**UPPER UWCHLAN TOWNSHIP  
PLANNING COMMISSION  
AGENDA  
September 10, 2020  
7:00 p.m.**

| II. Windsor Baptist Church – Final Land Development Plan<br>Review the Final Land Development Plan and consultants' comments for the @ 8,600 SF building addition to house the Christian Academy.  | 2             |

- Land Development Plan Set titled “Windsor Baptist Church” consisting of twenty (20) sheets, prepared by Ludgate Engineering Corporation, dated January 22, 2019, last revised April 14, 2020.

## POST-CONSTRUCTION DRAINAGE AREA PLAN

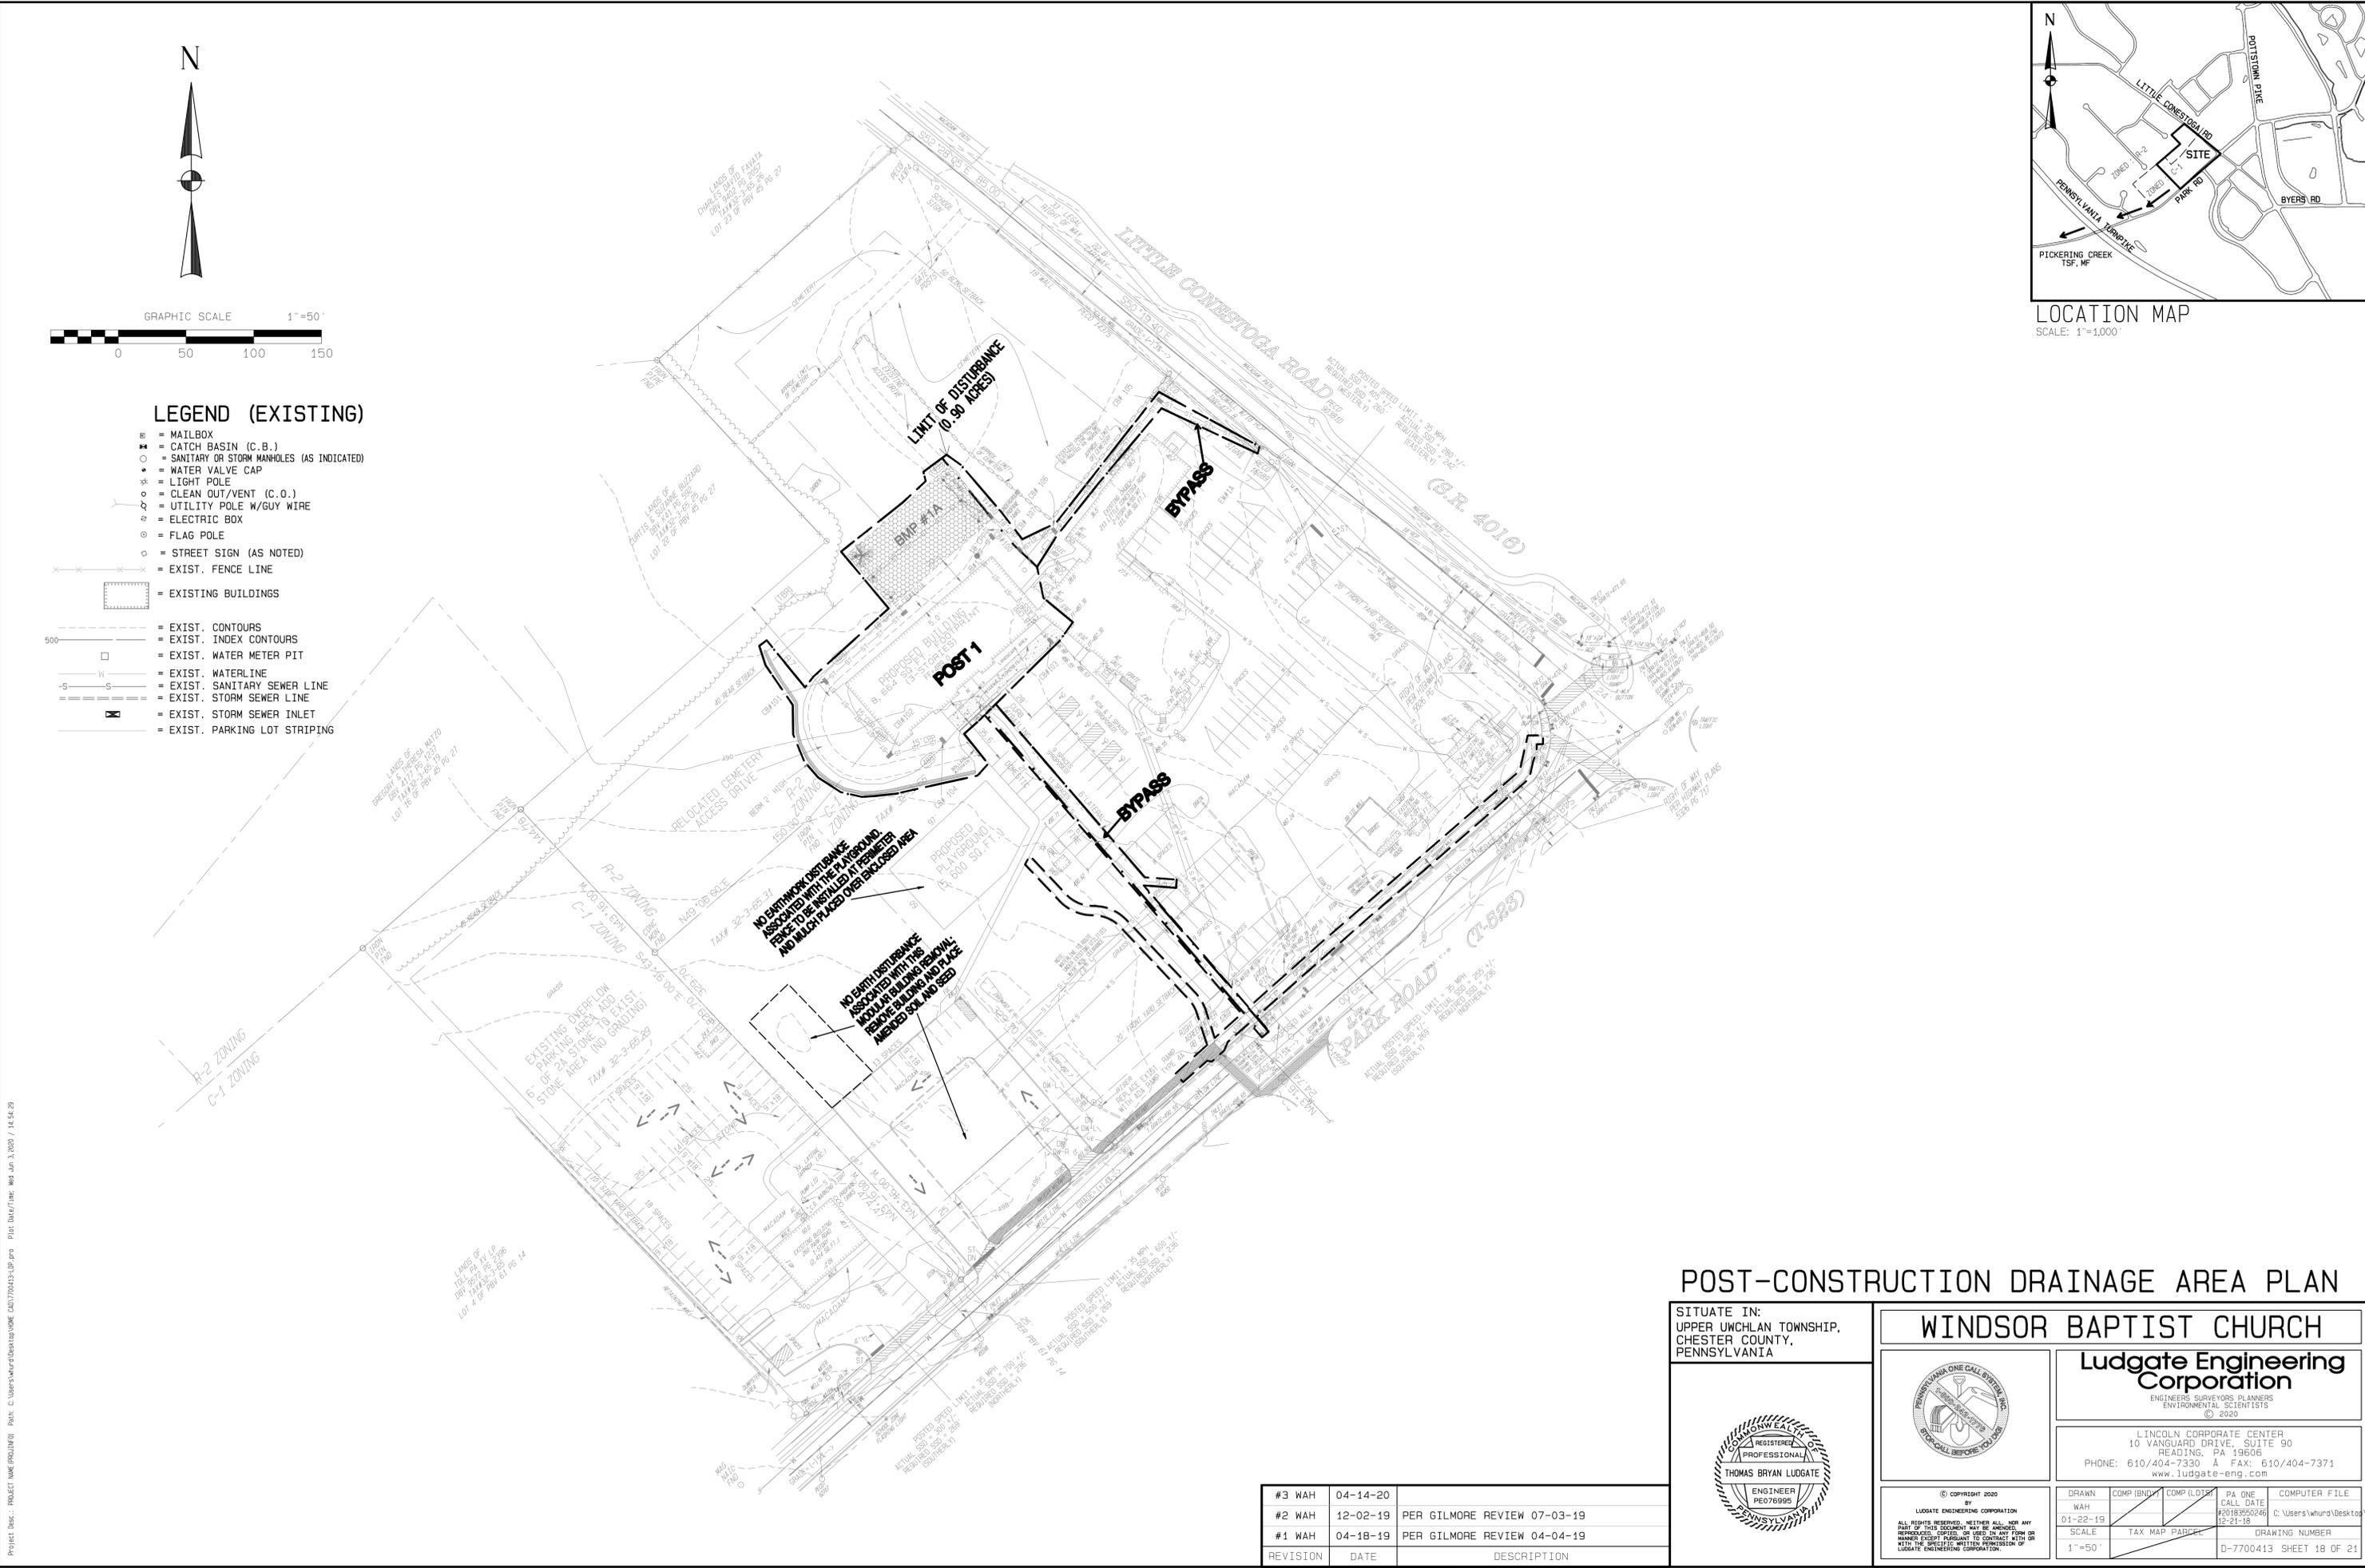
4. The size of the middle cleanouts within the infiltration bed to connect three 18" pipes shall be clarified on the plans. It is unclear if these cleanouts are 4"-6" at the surface or down into the bed, which would be very difficult to connect three 18" pipes together at these locations.
5. Please clarify what the duplicate or erroneous drainage area lines shown on the Pre-Construction Drainage Area Plan Sheet 17 are for. These lines do not match the 0.90 acres Limit of Disturbance lines shown on the Post-Construction Drainage Area Plan Sheet 18.
